**SHANNON DRIVE UTILITY IMPROVEMENTS  
ITB-26-04**

**ADDENDUM NO. 2**

**March 30, 2026**

**2 U7 D ST FIRE HYDRANT REPLACEMENT ALTERNATE #1 DETAIL**

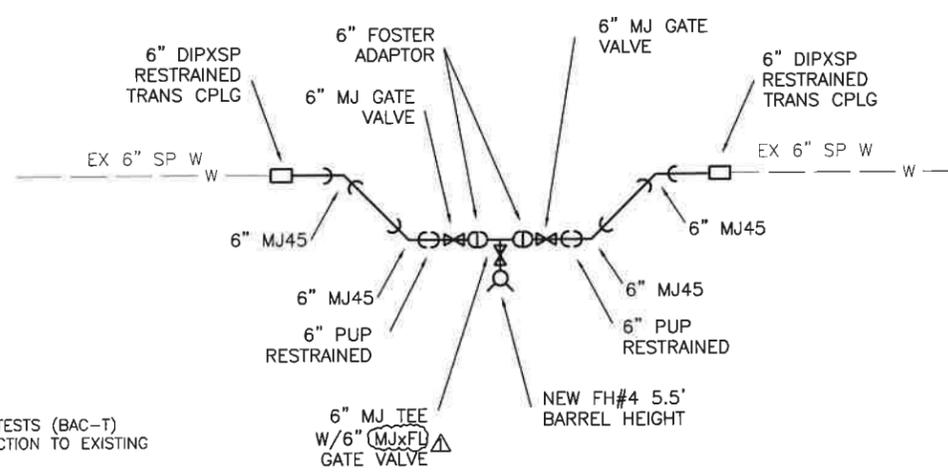
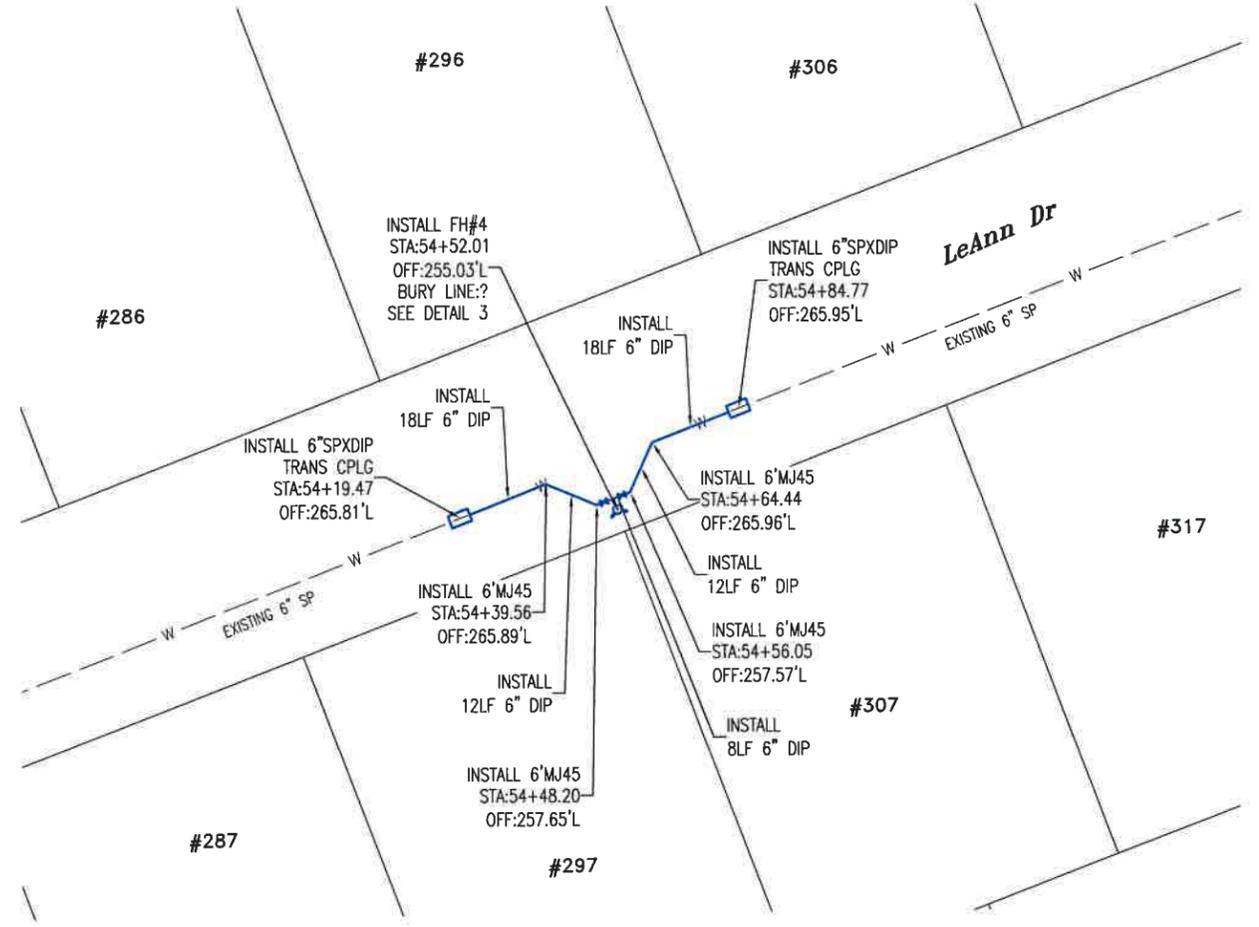
- NOTE**
- (2) BIOLOGICAL PURITY TESTS (BAC-T) REQUIRED BEFORE CONNECTION TO EXISTING MAIN.
  - PROVIDE AND INSTALL (2) BOLLARDS PER GHU STANDARD DETAIL WD1
  - ADDITIVE ALTERNATE #1 TYPICAL SECTION FOR ROADWAY REPLACEMENT: 2" HMA, TYPE II; CLASS B, ASPHALT BINDER GRADE PG52-28, 4" BASE COURSE, GRADING D-1, AND 12" SUBBASE GRADING F

**3 U7 LEANN FIRE HYDRANT REPLACEMENT ALTERNATE #2 DETAIL**

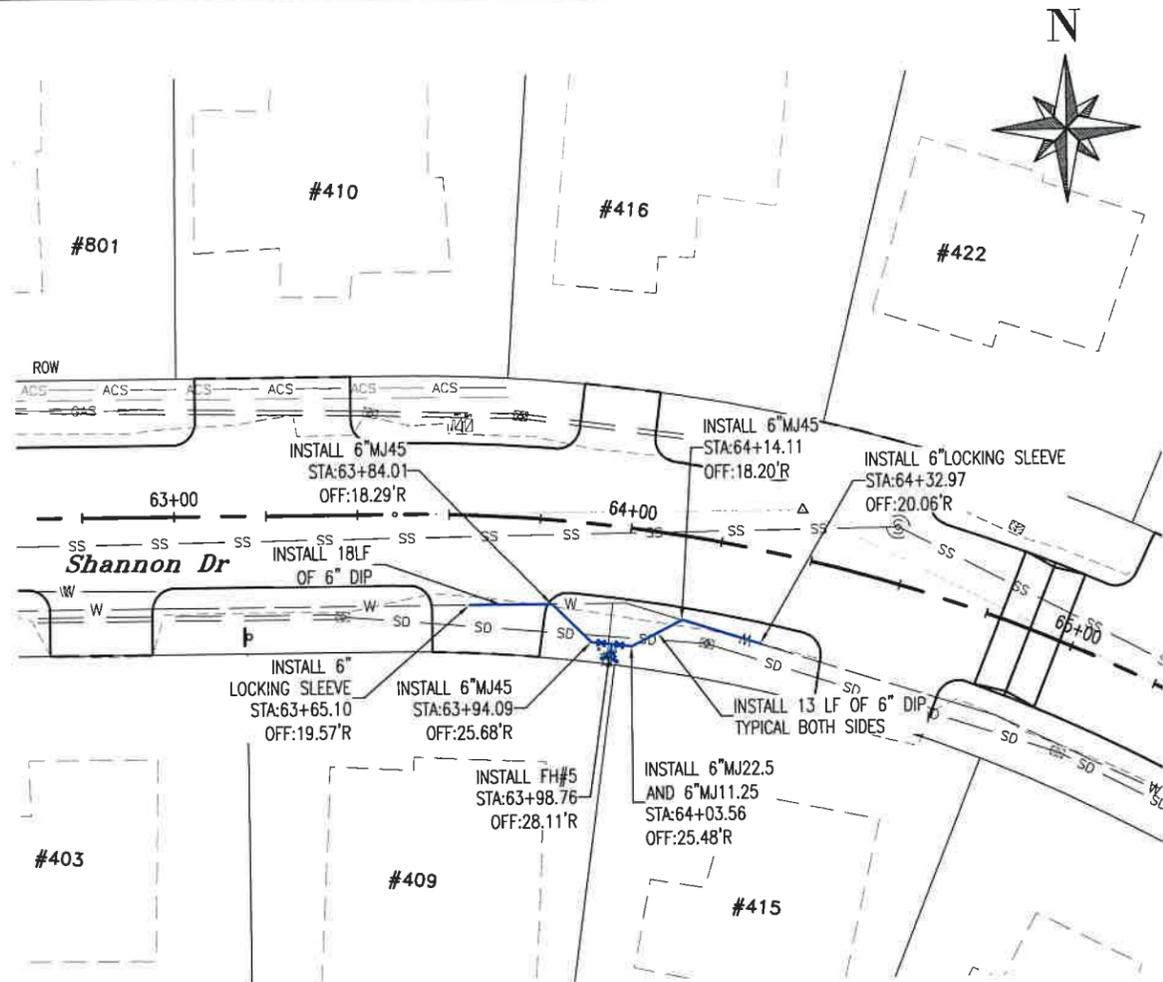
- NOTE**
- (1) BIOLOGICAL PURITY TESTS (BAC-T) REQUIRED AFTER CONNECTION TO EXISTING MAIN.
  - PROVIDE AND INSTALL (2) BOLLARDS PER GHU STANDARD DETAIL WD1
  - ADDITIVE ALTERNATE #2 TYPICAL SECTION FOR ROADWAY REPLACEMENT: 2" HMA, TYPE II; CLASS B, ASPHALT BINDER GRADE PG52-28, 4" BASE COURSE, GRADING D-1, AND 12" SUBBASE GRADING F

**5 U8 FIRE HYDRANT REPLACEMENT - FH#630 ALTERNATE #3 DETAIL**

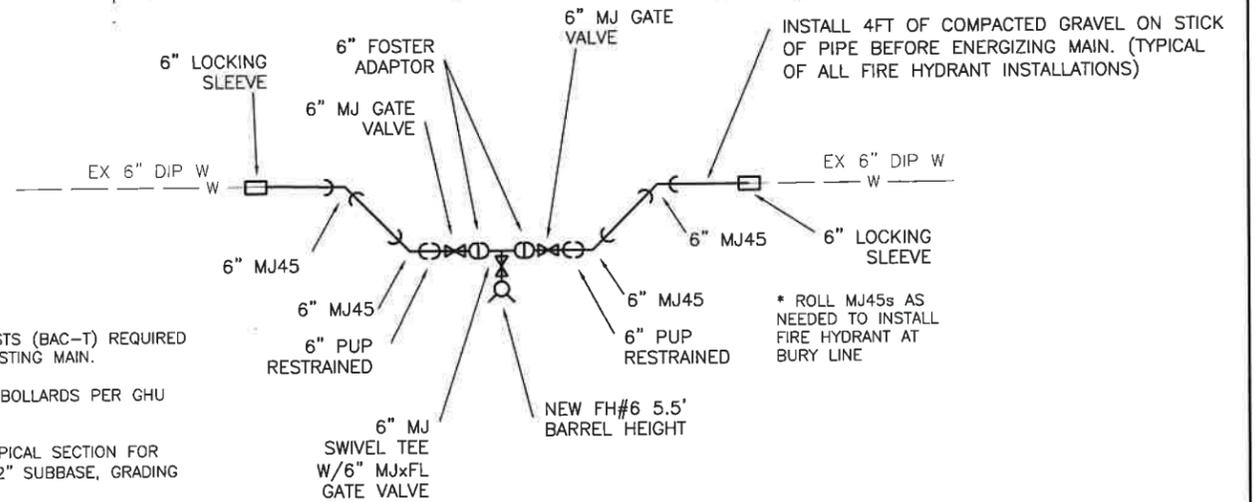
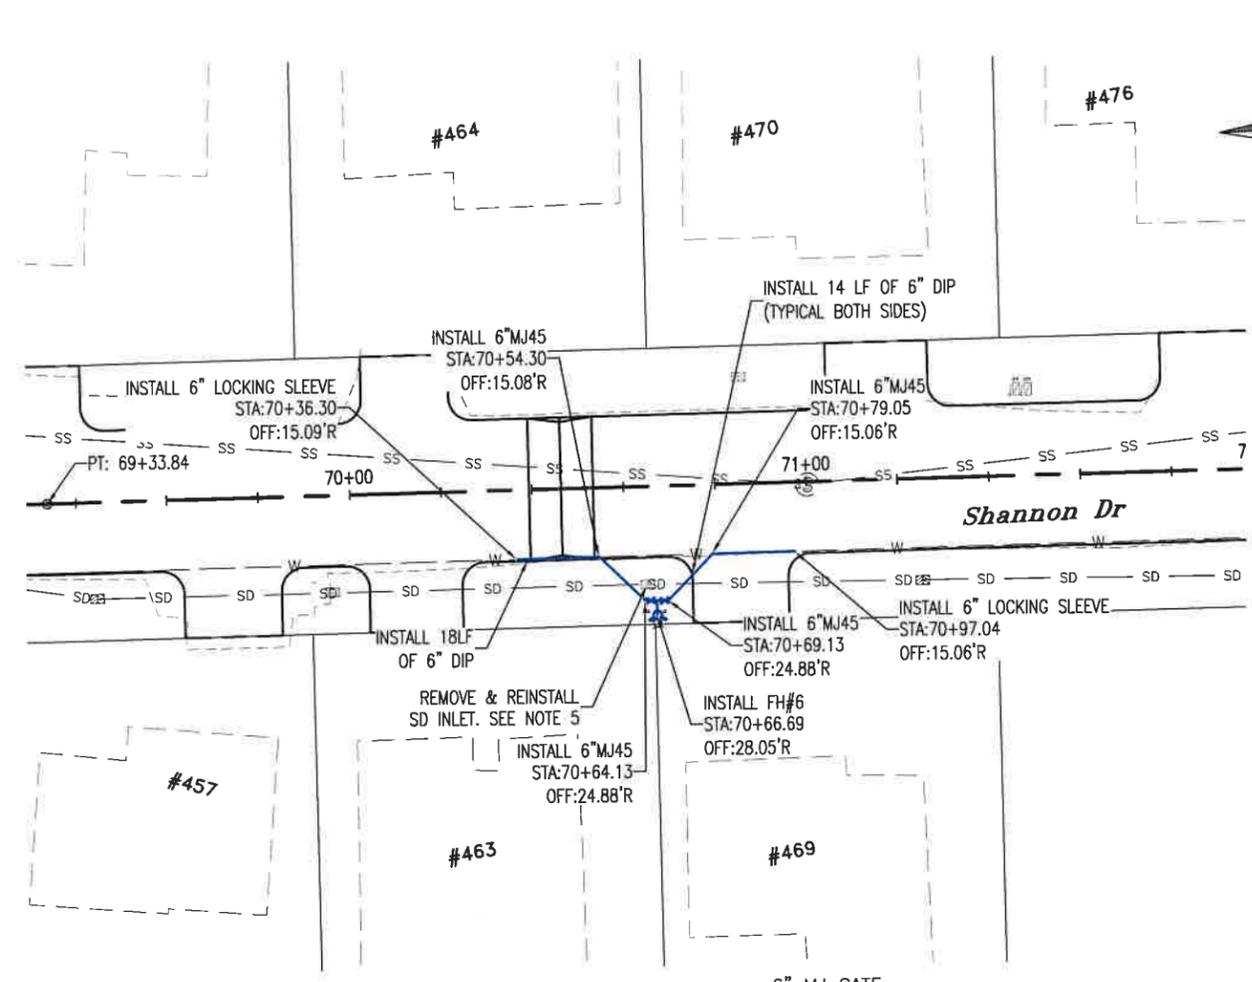
- (1) BIOLOGICAL PURITY TESTS (BAC-T) REQUIRED AFTER CONNECTION TO EXISTING MAIN.
- PROVIDE AND INSTALL (2) BOLLARDS PER GHU STANDARD DETAIL WD1
- ADDITIVE ALTERNATE #3 TYPICAL SECTION FOR ROADWAY REPLACEMENT: 12" SUBBASE, GRADING F.
- 2" HMA, TYPE II; CLASS B, 4" BASE COURSE, GRADING D-1 TO BE DONE BY OTHERS.

**6 U8 FIRE HYDRANT REPLACEMENT - FH#628 ALTERNATE #3 DETAIL**

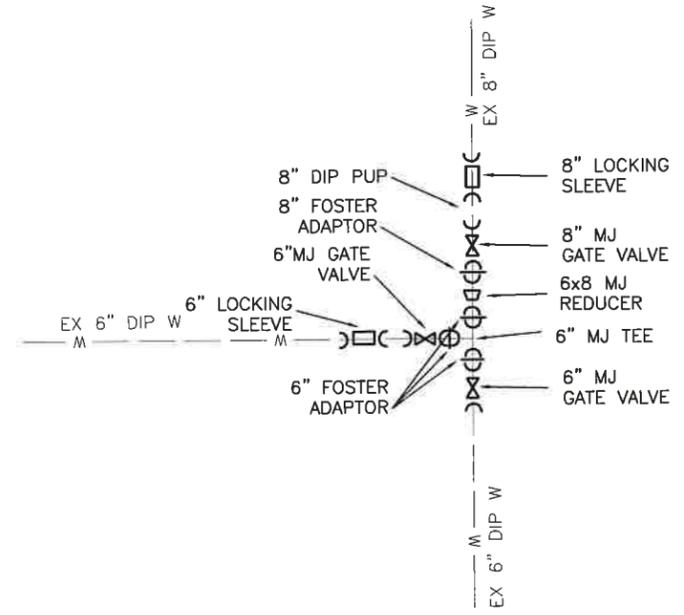
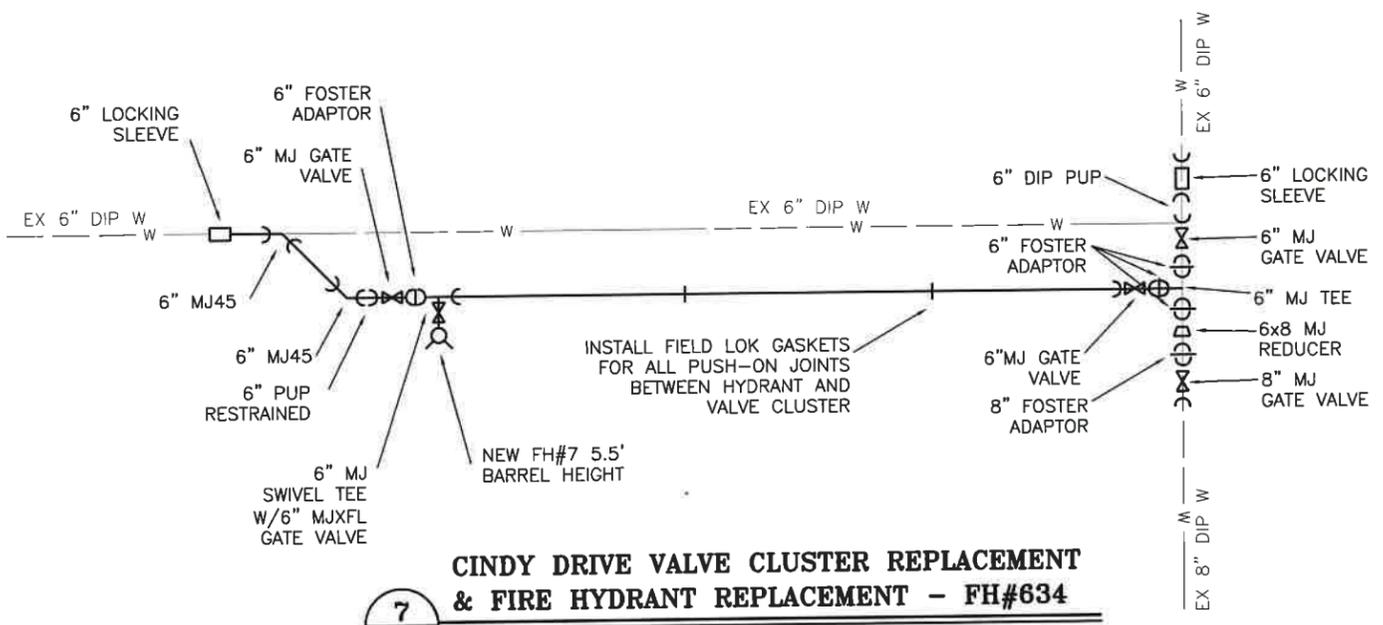
- (1) BIOLOGICAL PURITY TESTS (BAC-T) REQUIRED AFTER CONNECTION TO EXISTING MAIN.
- PROVIDE AND INSTALL (2) BOLLARDS PER GHU STANDARD DETAIL WD1
- ADDITIVE ALTERNATE #3 TYPICAL SECTION FOR ROADWAY REPLACEMENT: 12" SUBBASE, GRADING F.
- 2" HMA, TYPE II; CLASS B, 4" BASE COURSE, GRADING D-1, AND SPEED HUMP INSTALLATION TO BE DONE BY OTHERS.
- REMOVE AND REINSTALL EXISTING STEEL CAN INLET AS REQUIRED FOR FIRE HYDRANT INSTALLATION. CUT EXISTING 12" CSP PIPE AND REMOVE INLET. REINSTALL EXISTING STEEL CAN AND INSTALL NEW 12" CSP WITH DIMPLE BAND TO CONNECT TO EXISTING PIPE. FOAM AROUND PIPE AT PENETRATION.

**7 U9 CINDY DRIVE VALVE CLUSTER REPLACEMENT & FIRE HYDRANT REPLACEMENT - FH#634 ALTERNATE #4 DETAIL**

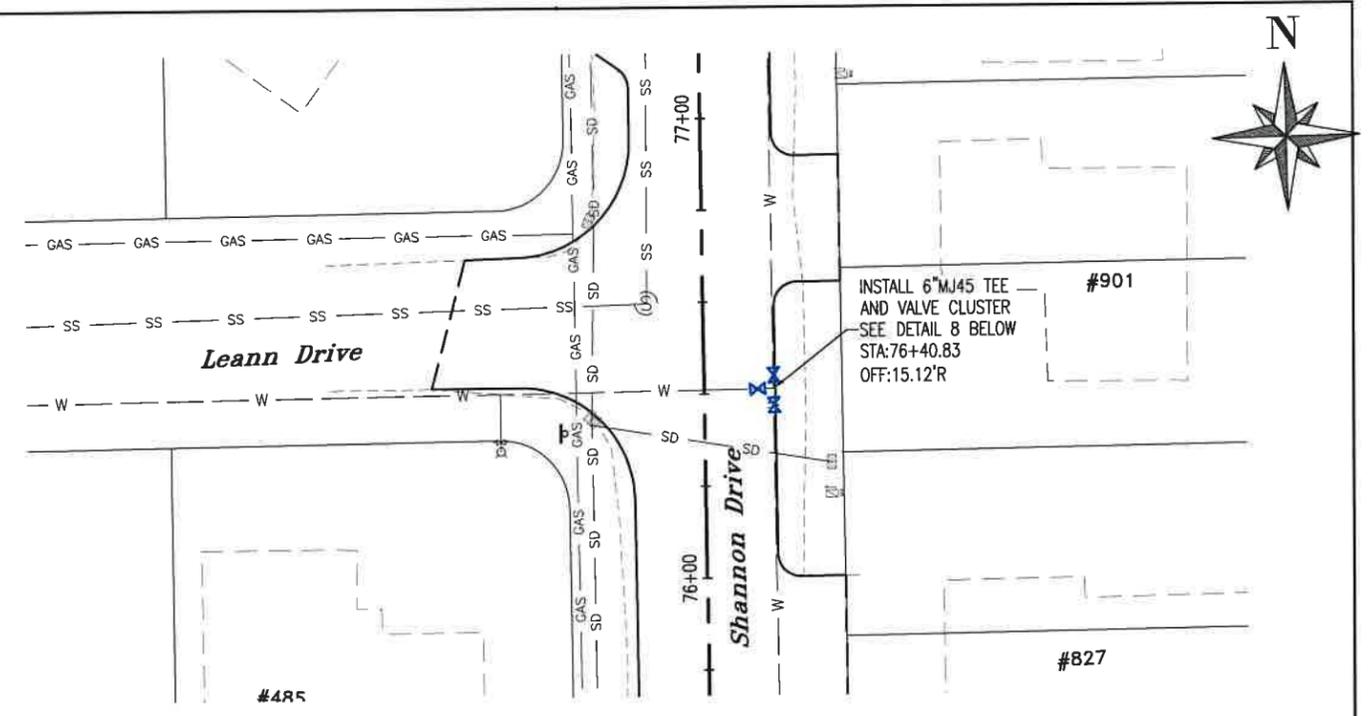
- NOTE**
- (1) BIOLOGICAL PURITY TESTS (BAC-T) REQUIRED AFTER CONNECTION TO EXISTING MAIN.
  - PROVIDE AND INSTALL (2) BOLLARDS PER GHU STANDARD DETAIL WD1.
  - ADDITIVE ALTERNATE #4 TYPICAL SECTION FOR ROADWAY REPLACEMENT: 12" SUBBASE, GRADING F.
  - 2" HMA, TYPE II; CLASS B, 4" BASE COURSE, GRADING D-1 TO BE DONE BY OTHERS.

**8 U9 LEANN DRIVE VALVE CLUSTER REPLACEMENT ALTERNATE #5 DETAIL**

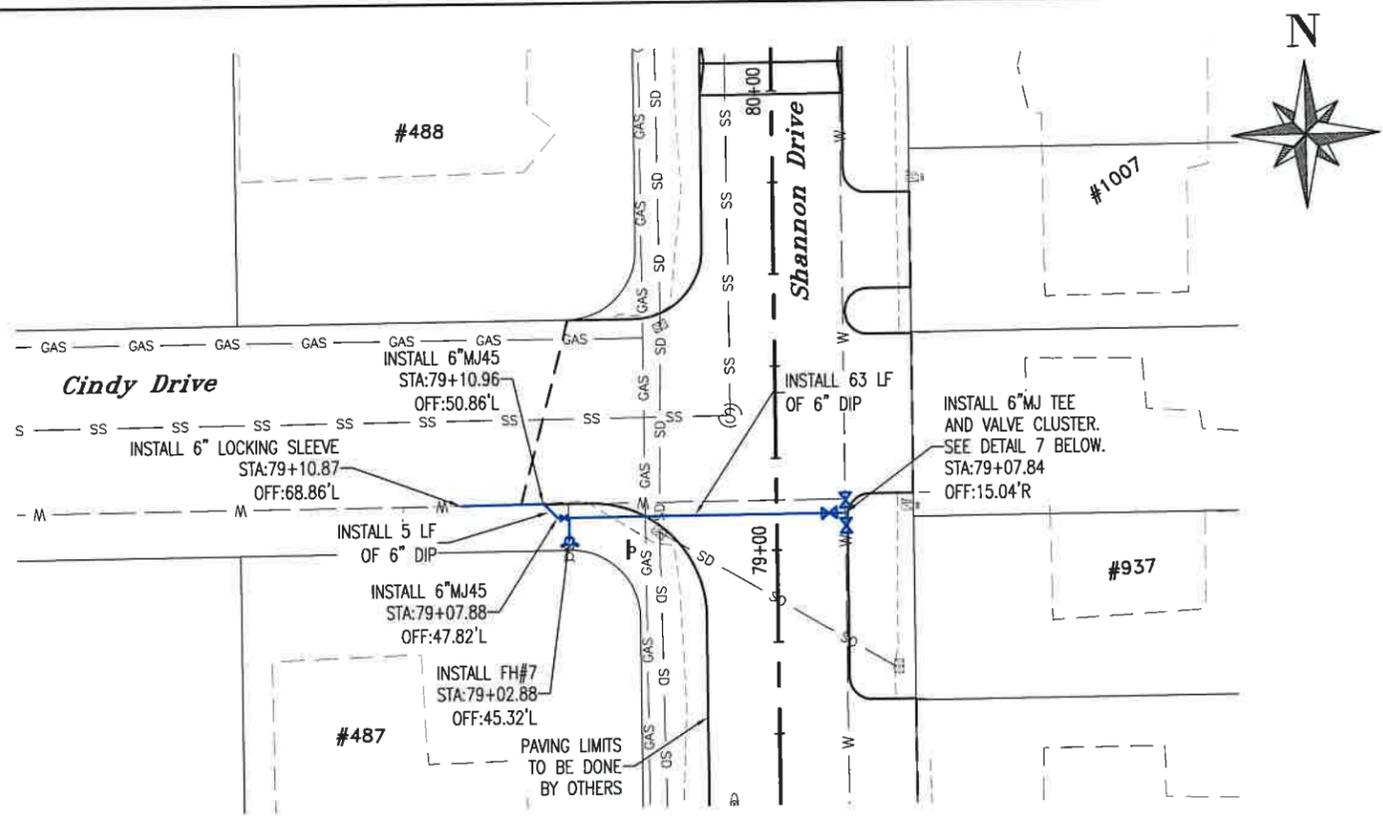
- NOTE**
- (1) BIOLOGICAL PURITY TESTS (BAC-T) REQUIRED AFTER CONNECTION TO EXISTING MAIN.
  - ADDITIVE ALTERNATE #5 TYPICAL SECTION FOR ROADWAY REPLACEMENT: 12" SUBBASE, GRADING F.
  - 2" HMA, TYPE II; CLASS B, 4" BASE COURSE, GRADING D-1 TO BE DONE BY OTHERS.
